Model: GF10		Date: 15-Dec-98	No: 1
Subject: Part number for the main motor		Prepared by: K.Takagi	
From: GTSS Field Information Dept.			
Classification:	<input type="checkbox"/> Troubleshooting	<input type="checkbox"/> Part information	<input type="checkbox"/> Action required
	<input type="checkbox"/> Mechanical	<input type="checkbox"/> Electrical	<input type="checkbox"/> Service manual revision
	<input type="checkbox"/> Paper path	<input type="checkbox"/> Transmit/receive	<input type="checkbox"/> Retrofit information
	<input type="checkbox"/> Other ()

Model: G Series, Schmidt Series		Date: 30-Jun-99	No.: RFMLU009
Subject: Vertical gray band		Prepared by: Y. Okunishi	
From: Technical Service Dept., GTS Division			
Classification:	<input checked="" type="checkbox"/> Troubleshooting	<input type="checkbox"/> Part information	<input type="checkbox"/> Action required
	<input type="checkbox"/> Mechanical	<input type="checkbox"/> Electrical	<input type="checkbox"/> Service manual revision
	<input type="checkbox"/> Paper path	<input type="checkbox"/> Transmit/receive	<input type="checkbox"/> Retrofit information
	<input type="checkbox"/> Other ()

Model: GF-10		Date: 15-Jul-99	No.: RG0250

Part composition for G0251001

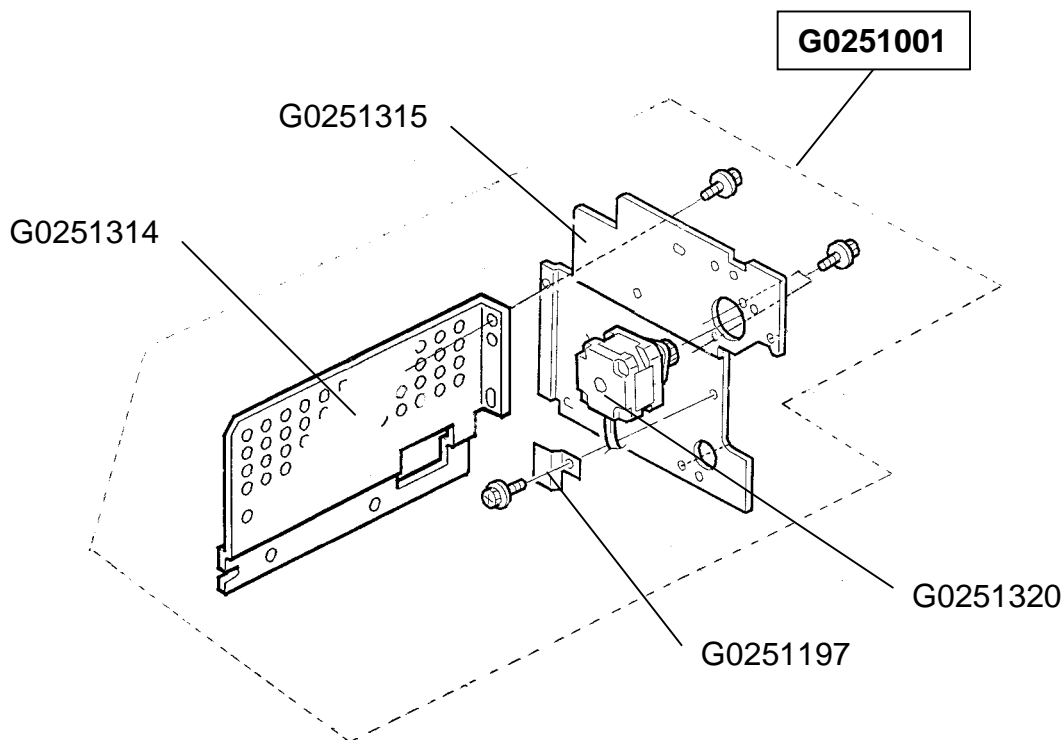
The service parts composition for the main motor has been changed as follows, because the manufacturer cannot supply the motor unit separately.

SPC can take orders only for part number **G0251001**, so the part number of **G0251320** will not be used for orders.

Old		New	
Part Number for Orders	Composition	Part Number for Orders	Composition
G0251320 (Main Motor – DC24V 0.7A)	G0251320	G0251001 (Motor Assy)	G0251320 G0251314 G0251315 G0251197

Firmware Recovery

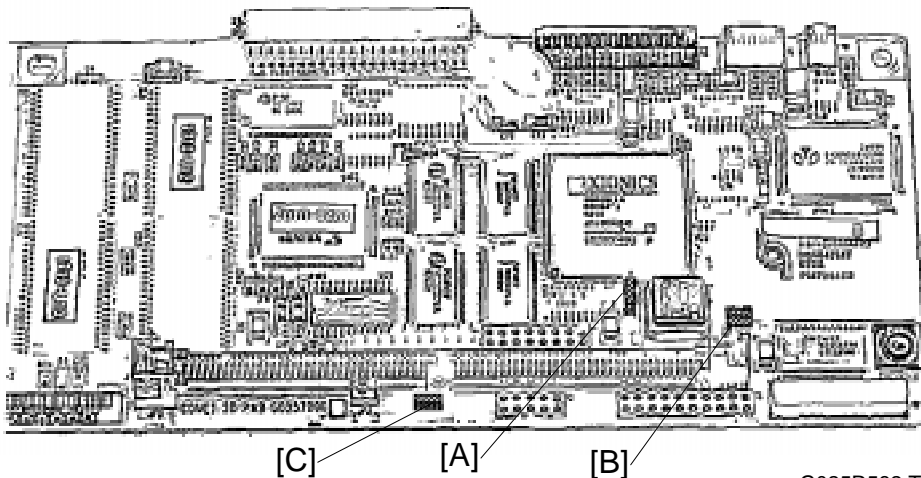
The firmware recovery procedure should be added to the service manual in section 6.

1. Turn off the main switch and then remove the SIMM from the control board.
2. Short JP4 [A], JP7 [B] and JP2 [C] on the control board.

3. Reinstall the SIMM on the control board.
4. Turn on the main switch.
After turning on the switch, wait more than 5 seconds.
5. Start up WinRICOHE on the personal computer and click "Select Prn Files" [D] on the display.

6. Select "Comet Firm Files" [E] from the file types and remove the checkmark next to "Interval" [F].
7. Open the folder that contains the new firmware file.
8. Select the recovery file [G].
9. Click "Start" [H].

10. After the counter changes back to "Start", wait more than 15 seconds. Then turn off the main switch.
11. Return JP2 to the open condition.
12. Turn on the main switch.
13. Execute Firmware Updating again (Replacement and Adjustment – Adjustment – Firmware Updating).

- GF10-1/2 -

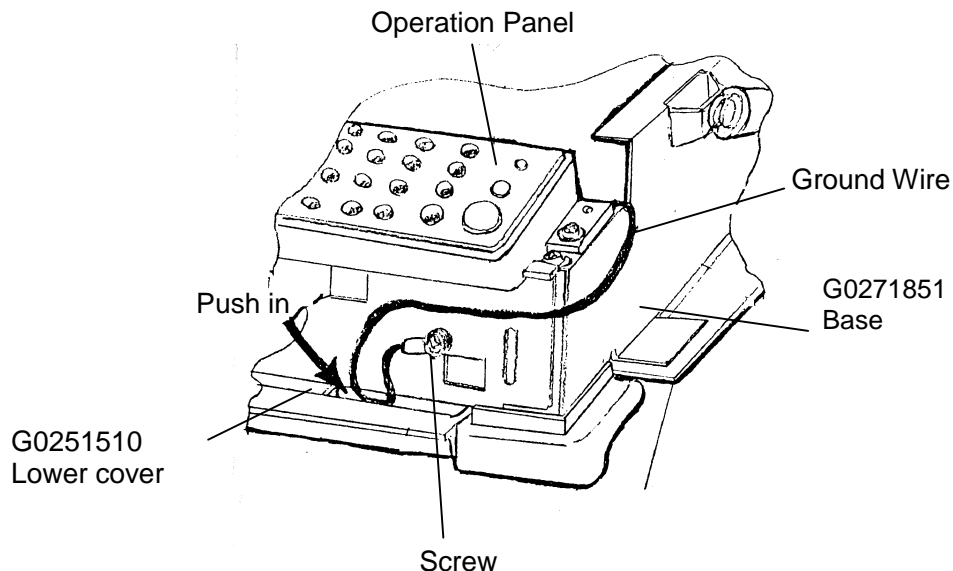
The ground wire of the operation panel has been extended so that it can be wrapped around the noise filter. This RTB shows how to attach the new operation panel.

The noise filter does not need to be attached to GF10-1/2 models. Due to the ground wire being relatively long, please follow the procedure described below to prevent the ground wire from getting caught between covers.

1. Attach the ground wire of the operation panel to the base of the scanner unit with one screw.
2. Push the loose wire into the gap between the base and lower cover (of the scanner unit).

- GS10 -

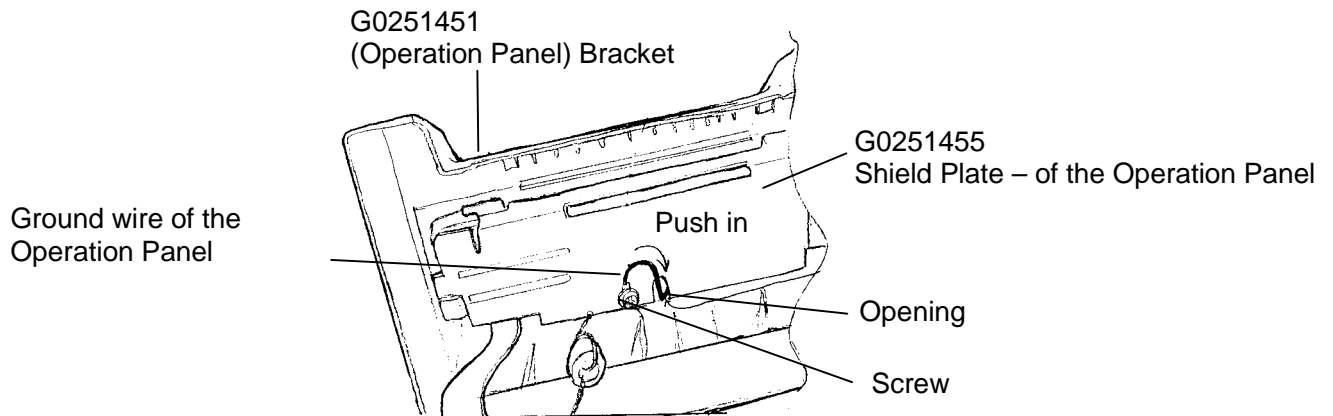
The noise filter does not need to be attached to GS10 models. Due to the ground wire being relatively long, please follow the procedure described below to prevent the ground wire from touching the ADF unit.

1. Attach the ground wire of the operation panel to the operation panel bracket.
2. Push the loose wire into the opening in the bracket.

A. The axis holder of the paper separation pad on the base frame unit:

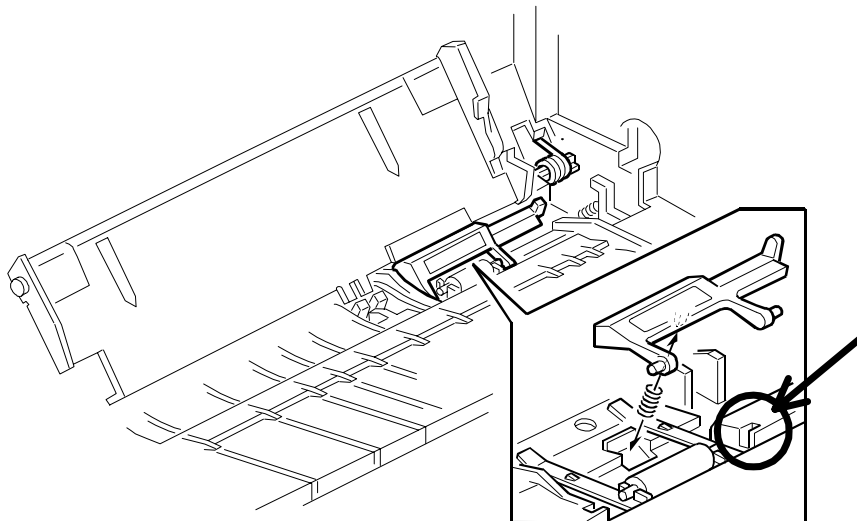
Please use the following solutions when a machine is returned to the repair center following frequent non-feed jams:

Solution 1: Apply grease to the 2 areas shown below.

Note: Be sure to use GREASE 501 (52039502).
